**City of Fairhope
Planning Commission Agenda
5:00 PM
Council Chambers
August 7, 2023**

City of Fairhope Planning Commission

UR 23.08 - Mediacom Coaxial Cable Installation

SD 23.23 - 350 N. Bayview

TRACERY SUBDIVISION

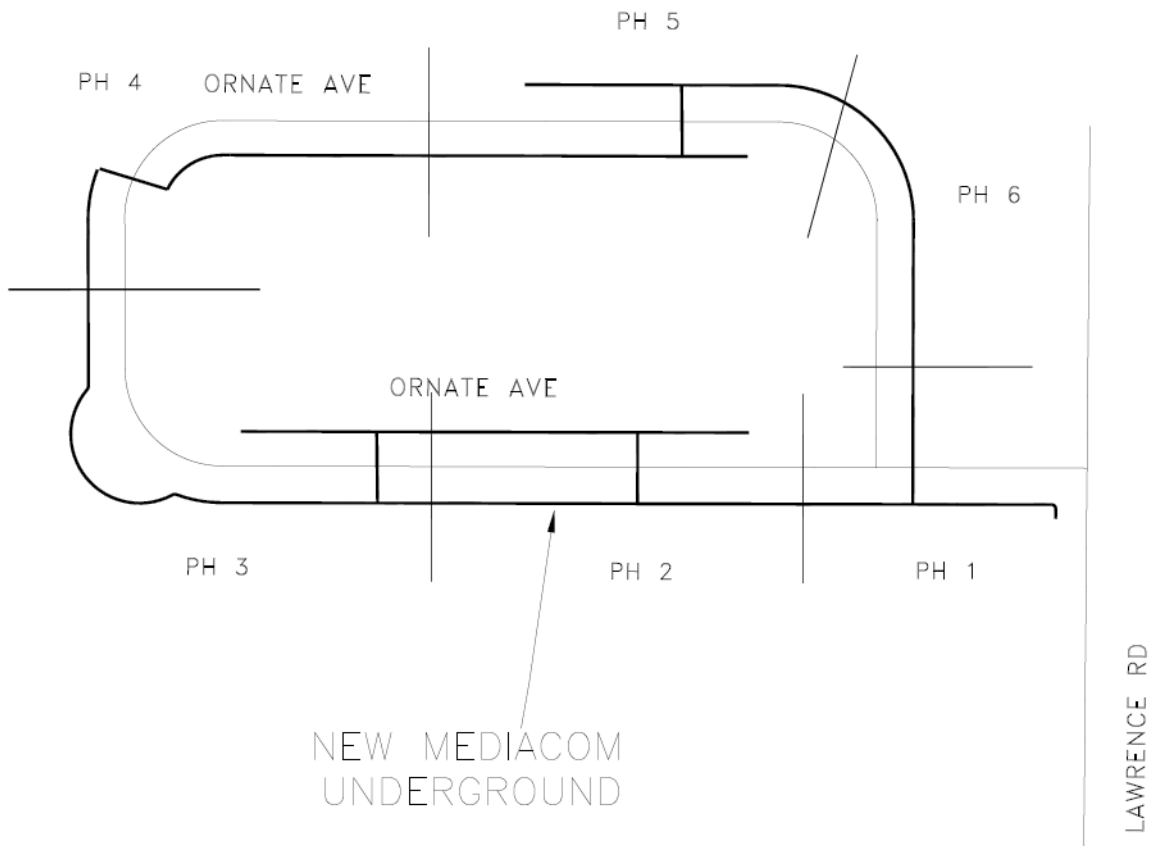
Summary: Hunter Simmons, Planning and Zoning Director, explained that Mediacom is installing coaxial cable which is not able to be buried. Staff asked Mediacom if they could use fiber optic so that the cable could be buried. Mediacom replied that it was too expensive. Mr. Simmons shared a slide showing the pedestals that would be installed above ground for the coaxial cable.

Rebecca Bryant stated that she is not crazy about the big plastic green boxes littering the downtown. Chairman Turner agreed and stated if there was the option to go underground, they should.

Mr. Simmons stated that since Mediacom is not present at the meeting, UR 23.08 will be withheld until the August meeting.

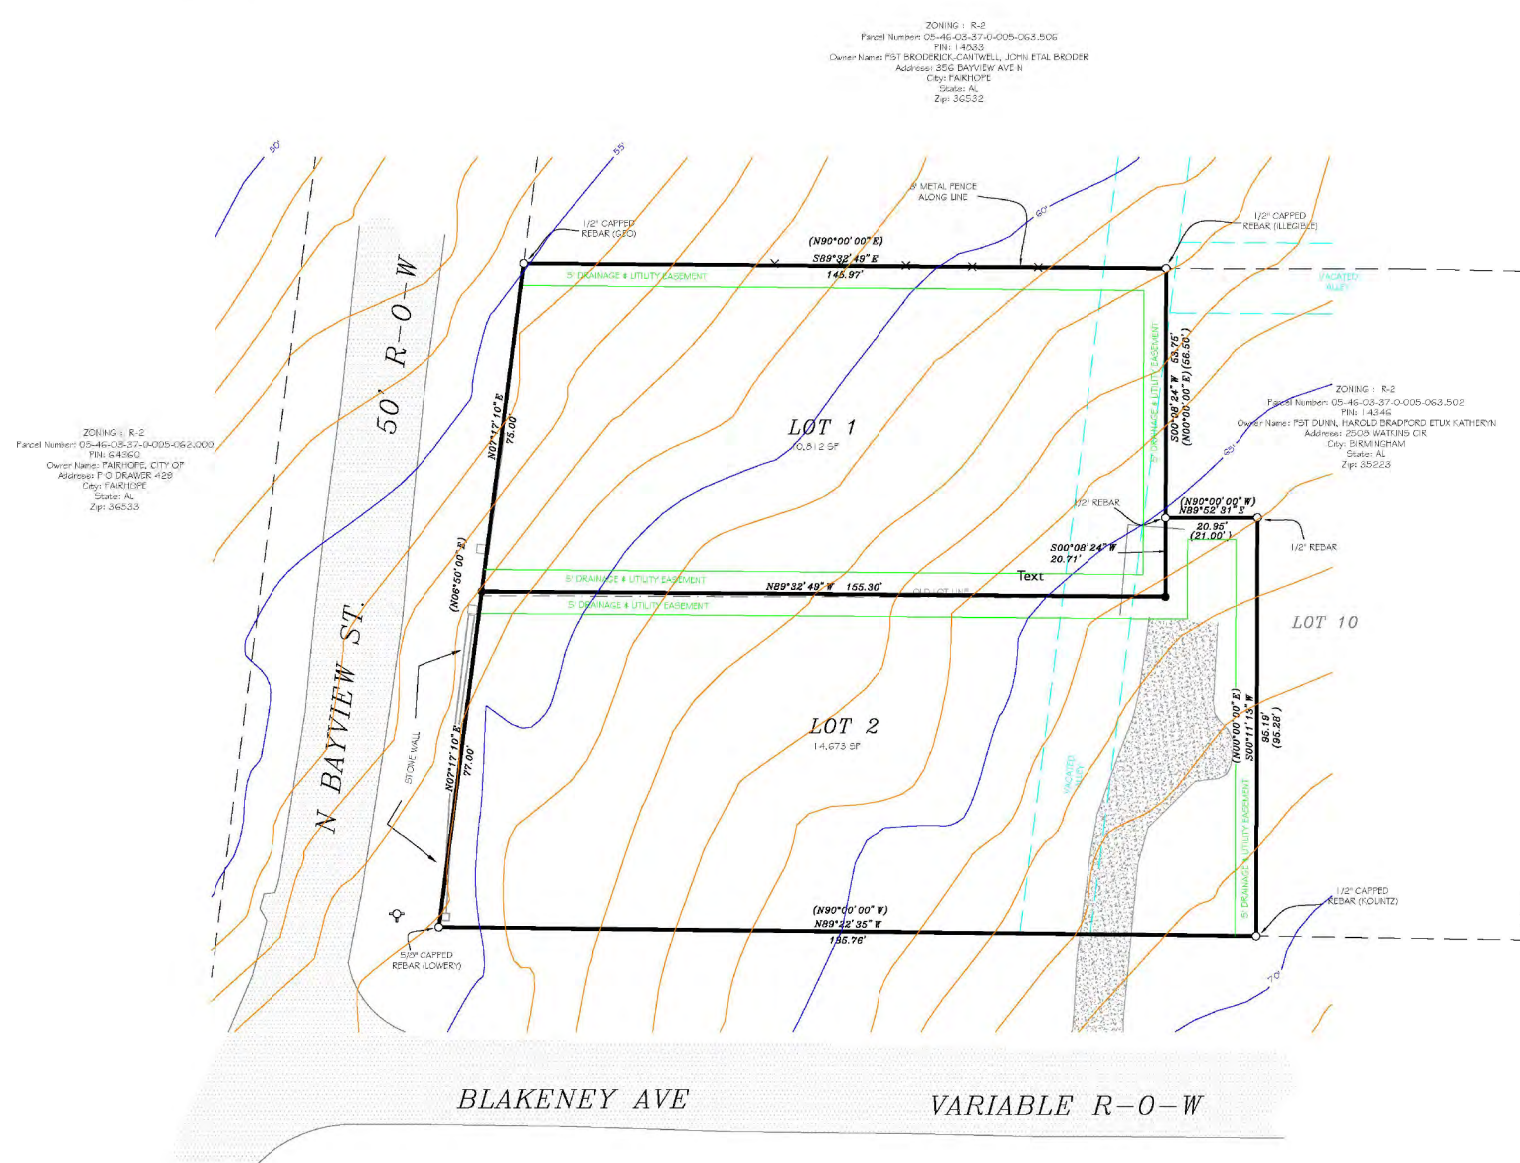
- All lots front on a publicly maintained road and meet the lot size requirements.
- Planning Commission heard a subdivision case SD 23.03 for this property at the March 6, 20223 meeting and voted to approve the case with the following conditions:
 1. The accessory structure is removed.
 2. Easements are granted for the sidewalk, utilities and drainage.
 3. A solution to the fire flow is reached between the City and owner.
 - The approval expired July 4, 2023.
- The differences are outlined below:
 - The accessory structure has been removed and the property is now completely vacant.
 - Drainage plan prepared by an engineer has been submitted for review.

- The applicant has provided an engineered drainage plan provided by Chris Lieb with Lieb Engineering and is requesting a waiver from the standard drainage easements listed in the subdivision regulations. Altered drainage easements are shown on the plat per the drainage plan. The plan includes drainage work in the Blakeney Avenue Rights of Way and has been reviewed by Fairhope Public Works Director, Richard Johnson, PE. Staff supports the waiver with a note on the plat memorializing this case number to reference the drainage plan to be reviewed during future building permits.

- Electric, Water, Sewer, and Gas are provided by the City of Fairhope.
 - Fairhope Utilities have indicated there is adequate room in the ROW to service the two proposed lots and support a waiver to not provide the required 15' Utility easements.
- Telephone is provided by AT&T
- Based off the flow model the applicant's engineer has stated that installing an automatic fire sprinkler system meets the current ISO Fire Suppression Rating Schedule Paragraph 340 Exception 1. The city requires fire flow to meet International Fire Code and it does not.
- Currently state law prohibits Building Departments from requiring sprinkler systems in one-family or two-family dwellings.

- Sidewalks do not exist along either of the existing roads adjacent to this subdivision. The Subdivision Regulations allow for the Planning Commission to allow for a 10' sidewalk easement in lieu of installing sidewalks due to the absence of other sidewalks in the proximity to the subdivision. The applicant is asking for a waiver from installing sidewalks or providing an easement. Waiver requests are included in the Planning Commission packet. Staff does not support the waiver request. Staff is in support of an easement in place of the sidewalk as permitted by the subdivision regulations.

1. Planning Commission approval of the Drainage/Utility Easement modification Waiver
2. Adding a 10’ sidewalk pedestrian easement along the property lines adjacent to the ROW’s.
3. A solution to the fire flow is reached between the City and owner.
4. Add note to the plat “At time of permitting refer to Planning Commission Case SD 23.23 for drainage requirements.”

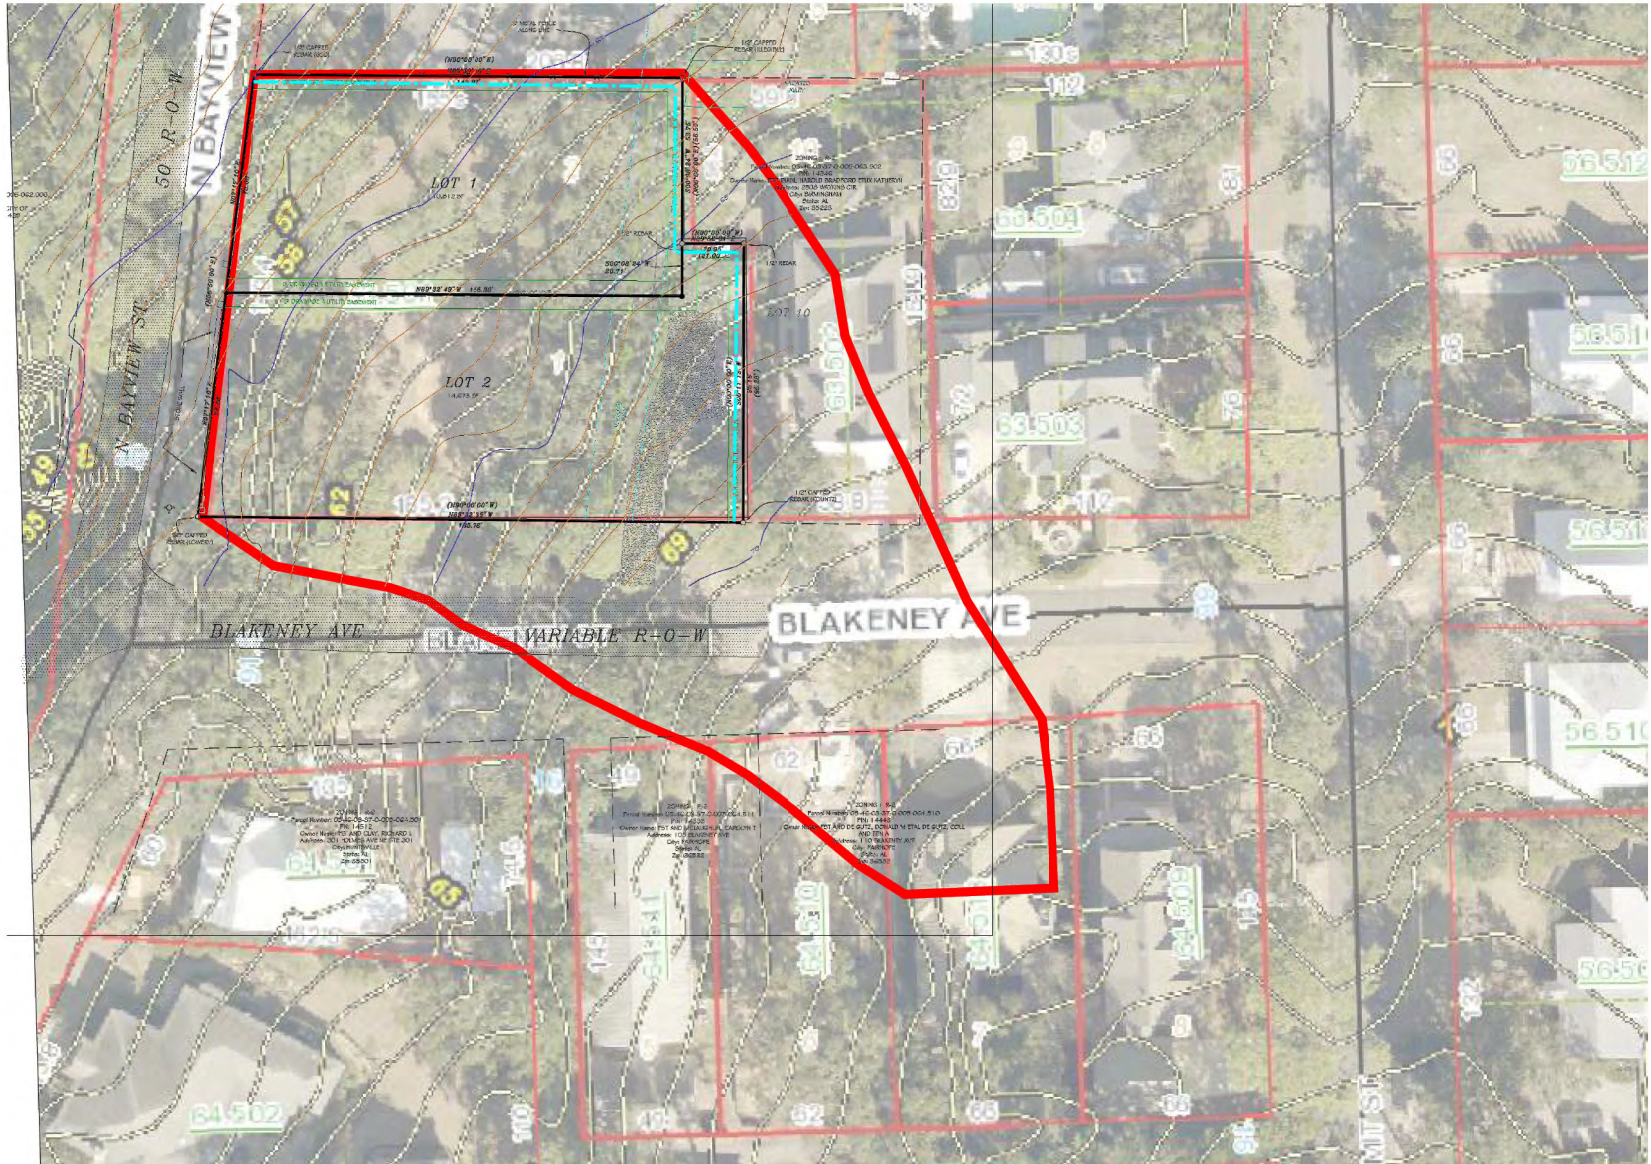
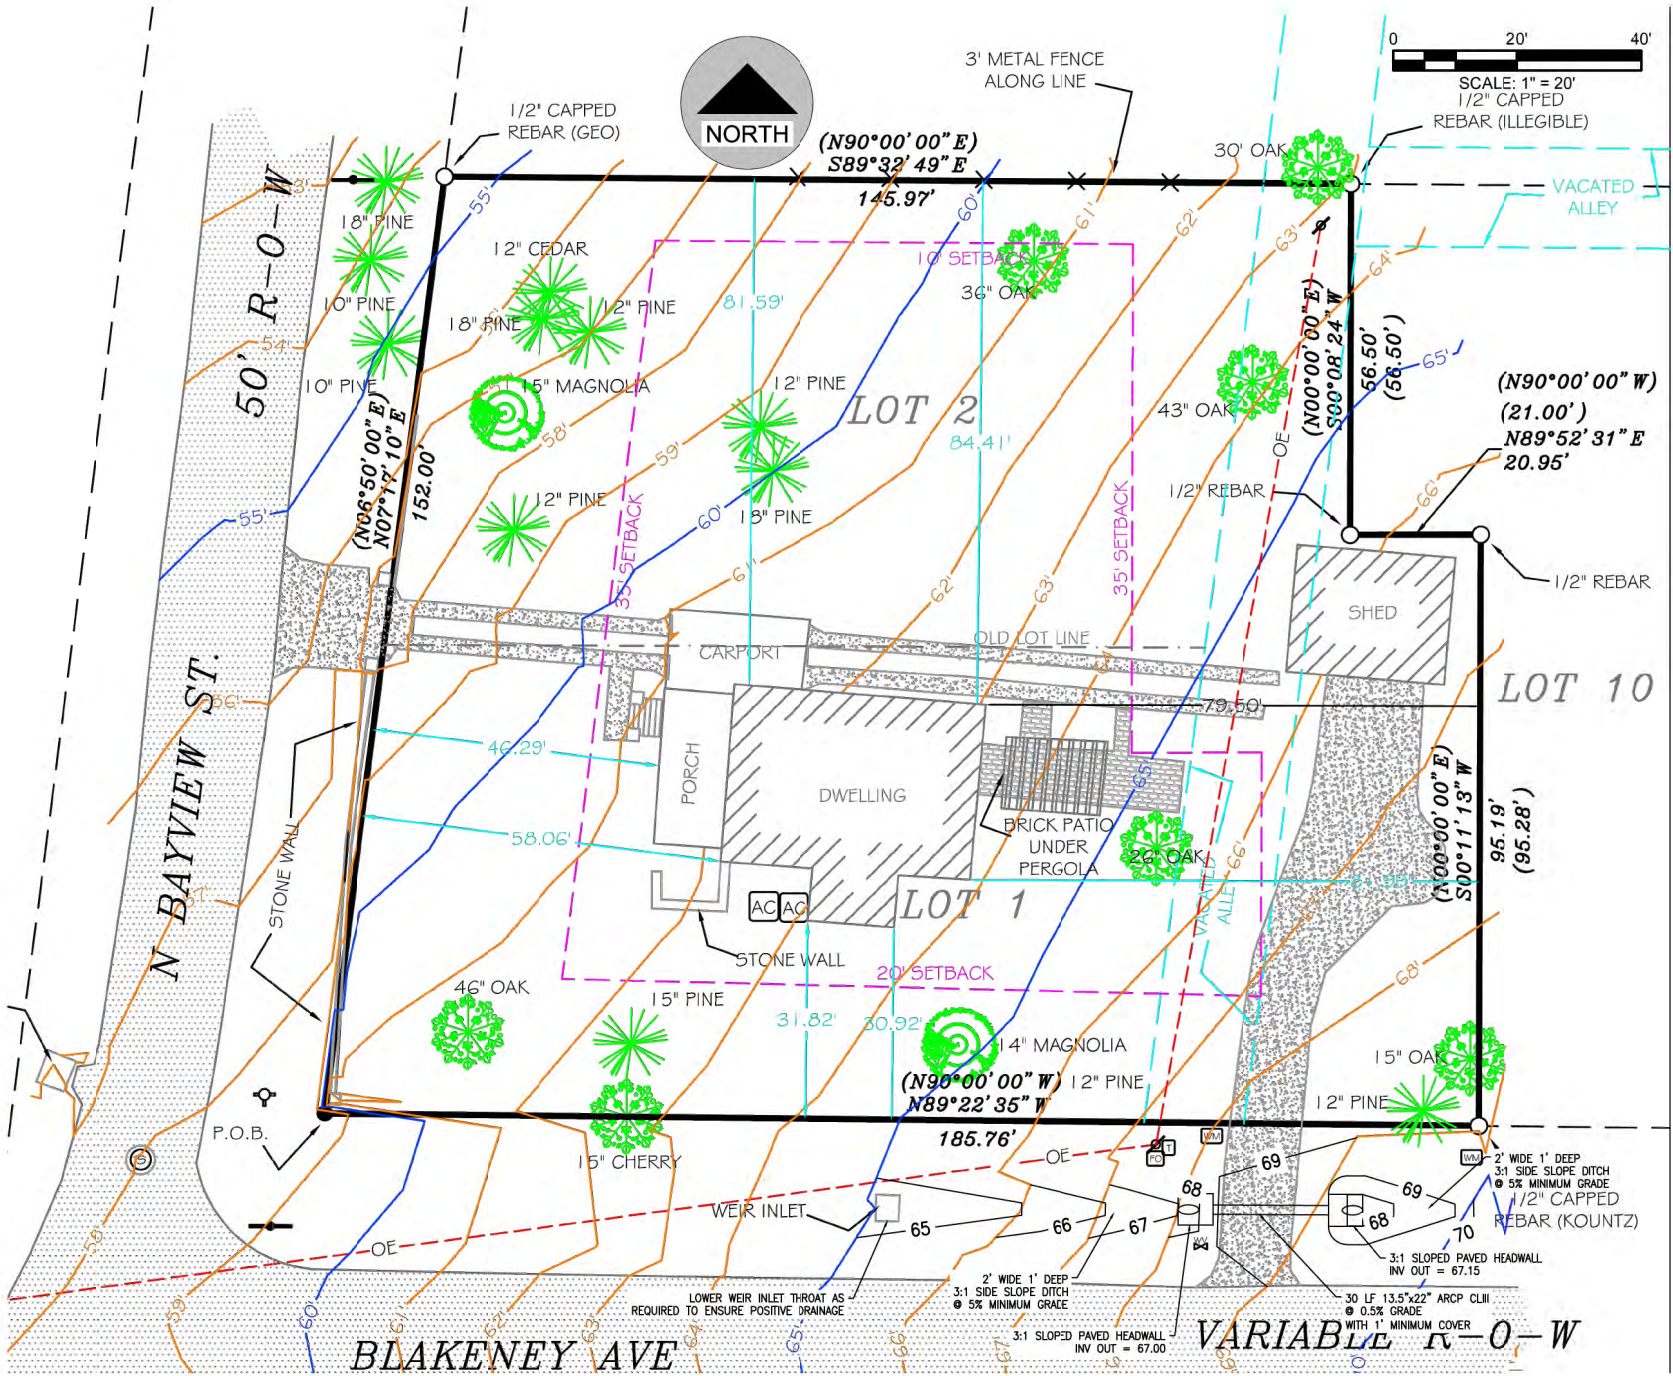
A 24" round culvert with a slope of 10% will safely convey the 25 year storm. The culvert report is attached.

Therefore the 5' wide drainage easements are sufficient to convey the 25 year storm.

Please note, if the need to use the drainage easements were to arise, a solution that should be considered would be a swale/ditch to be installed on the north side of Blakeney Drive that cuts off the storm water from the road and leads it to the weir inlet located in the ROW. If additional drainage were needed, the east easements of lots 1 and 2 could be utilized to catch and convey the water that is south/southeast of its location and turn it to the west along the north easement of Lot 1.

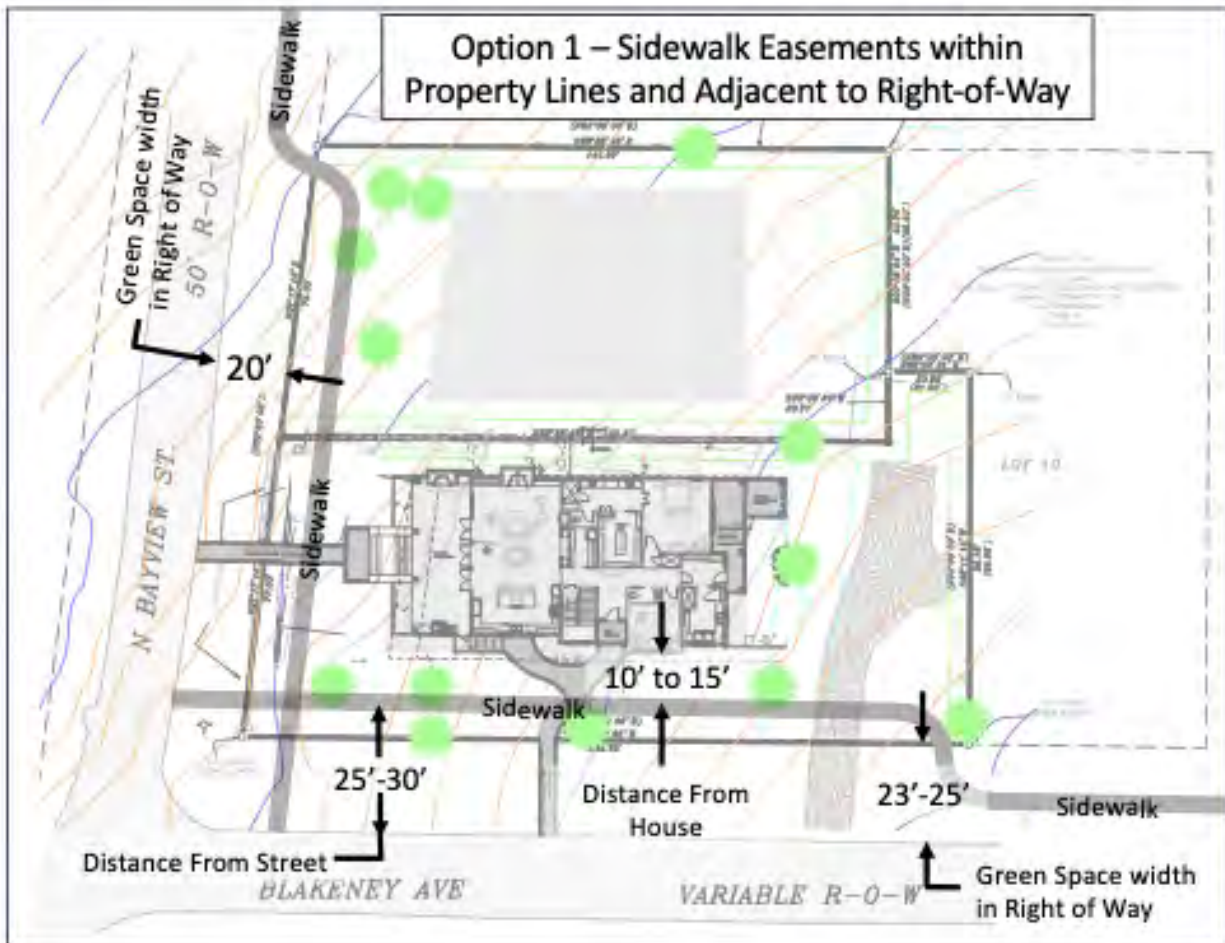
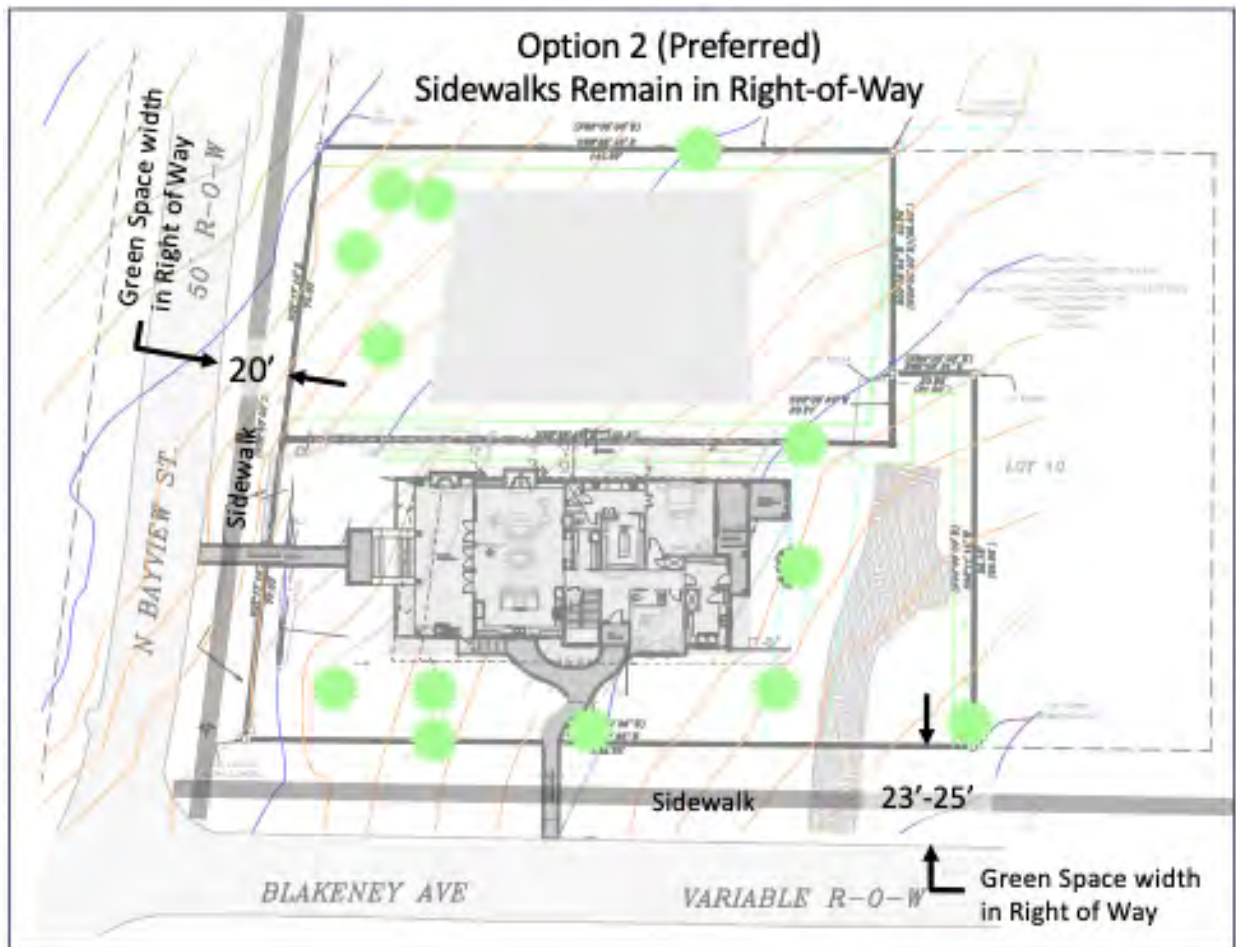
The Planning Department at the July 12th DRC meeting offered two options for not installing sidewalks now:

Option 1 - A 10' pedestrian easement within the lot boundaries and adjacent to the Right-of-Ways.

Option 2 – Future sidewalks to remain in existing Right-of-Ways.

Option 1 – Placing the sidewalk easements within the property lines and adjacent to the Right-of-Ways results in the following concerns:

- a) Tree Preservation – Sidewalks placed in this easement would endanger the root system of numerous Heritage Trees (46” live oak tree, two 15” live oaks, 15” cherry tree and two 14” magnolias). Our tree arborist recommends no construction within a 10’ to 20’ radius (depending on tree size), thus advising against a sidewalk easement in this area.

- b) Atheistic Appeal on Bayview - The sidewalks if ever installed would be 20’ to 30’ from the streets and 25’ from the house frontage. This would create the appearance of the sidewalk being in the middle of the front yards along Bayview.
